Agenda Item #: 2 SUB-002638-2023

Harris Subdivision

- Subdivision approval to create three (3) legal lots of record from one (1) legal lot of record.

DETAIL SITE PLAN

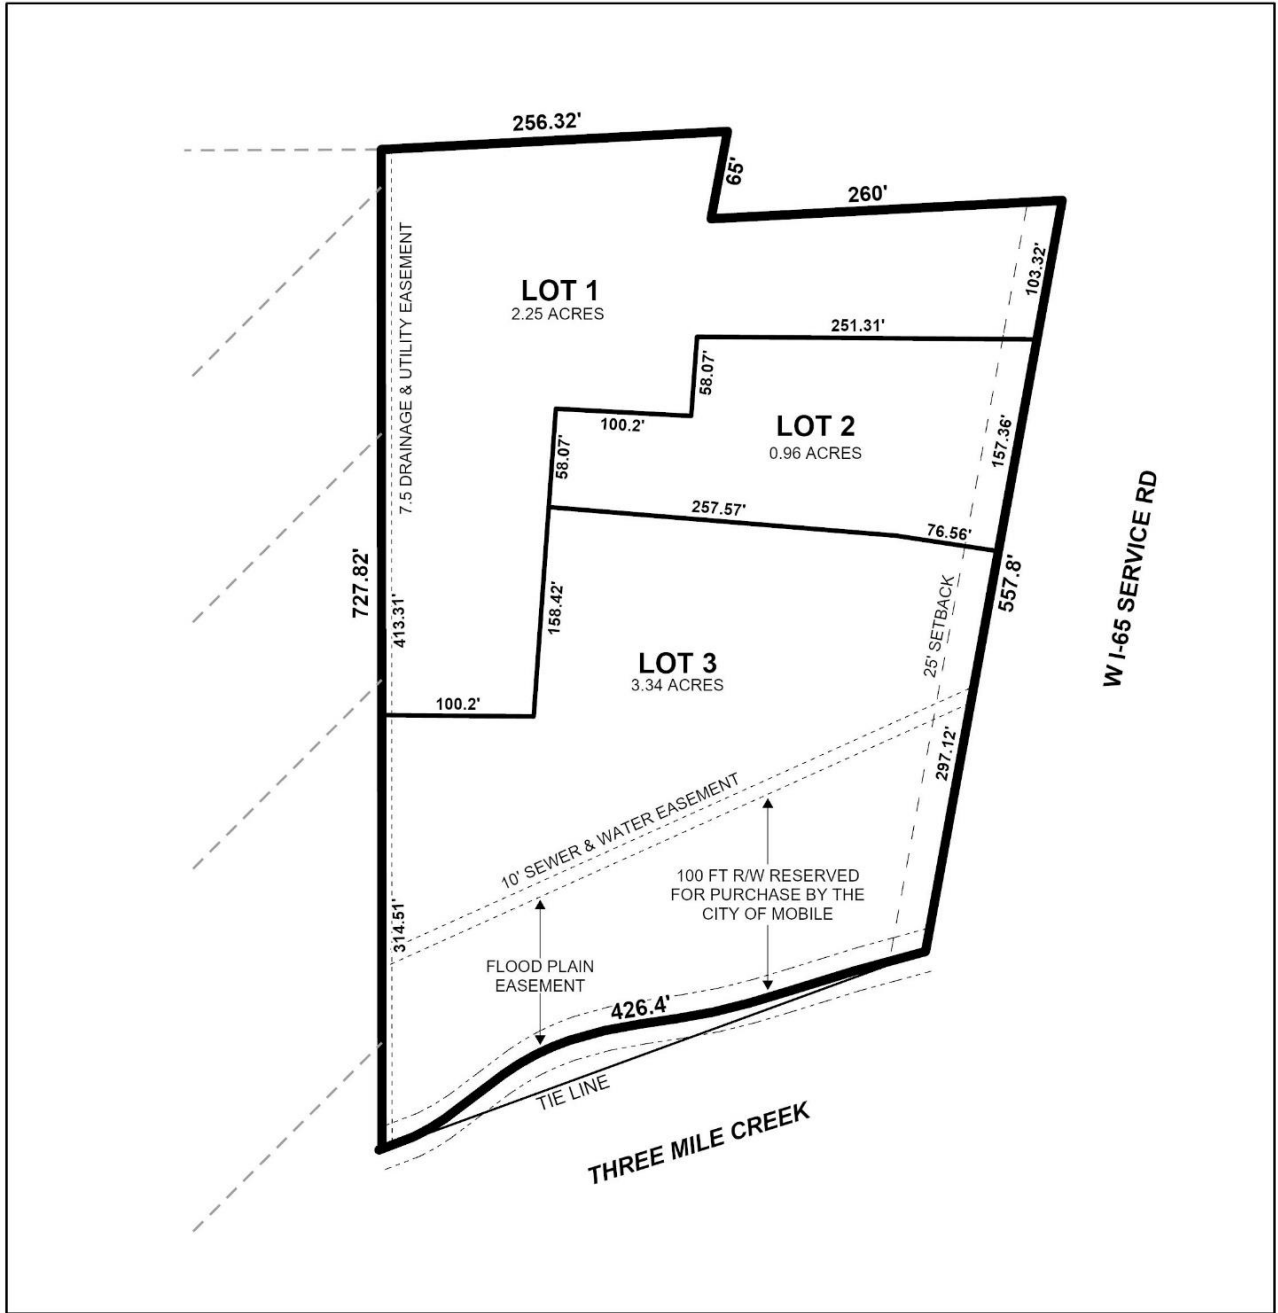
- B. Check the TOTAL AREA listed and the SMALLEST LOT listed. The numbers shown for each LOT don't add up correctly.
- C. Label the rectangular shape shown at the NE corner of LOT 3.

- D. National Wetlands Inventory (NWI) mapping, as shown on City of Mobile GIS information, indicates that there is potential for wetlands within the property or properties shown on this plat. Show and label the delineated wetlands, or provide a note stating that the wetlands shown on this plat are scaled from the NWI data and have not been delineated.

- E. Provide a note that a 25' riparian buffer may be required, during development, along the edge of anything considered by ADEM to be a water of the state.

- F. Show and label all flood zones. It appears that LOT 3 contains a bit of both AE and X(S) flood zones.
- G. Show and label the MFFE (Minimum Finished Floor Elevation) on each lot that contains an A, AE, or X (shaded) flood zone designation. BFE = 40.

- H. Add a note to the SUBDIVISION PLAT stating that as shown on the 1984 aerial photo (FLIGHT 24 - #72) LOTS 1, 2 and 3 will receive historical credit of existing (1984) impervious area towards stormwater detention requirement per Mobile City Code, Chapter 17, Storm Water Management and Flood Control) as follows: LOT 1 – 22,000 sf, LOT 2 – 30,000 sf AND lot 3 – 2,000 sf.

The site has frontage on West I-65 Service Road North, an ALDOT-maintained street that services Interstate 65 and requires a 300-foot right-of-way. No right-of-way is depicted along the I-65 Service Road North at this location. While GIS maps indicate there is adequate right-of-way, the plat should be revised to depict that there is sufficient right-of-way along West I-65 Service Road North.

The depth of Lot 1 is greater than 3.5 times its width, which is discouraged by Section 6.C.3 of the Subdivision Regulations. However, such a lot design does not appear to be uncommon within the vicinity of the subject site, with the Planning Commission having approved several of them. As such, a waiver of Section 6.C.3 may be appropriate.

The preliminary plat illustrates multiple easements on the site. These easements should be retained on the Final Plat, if approved, with a note stating that no structure shall be constructed in any easement without permission of the easement holder.
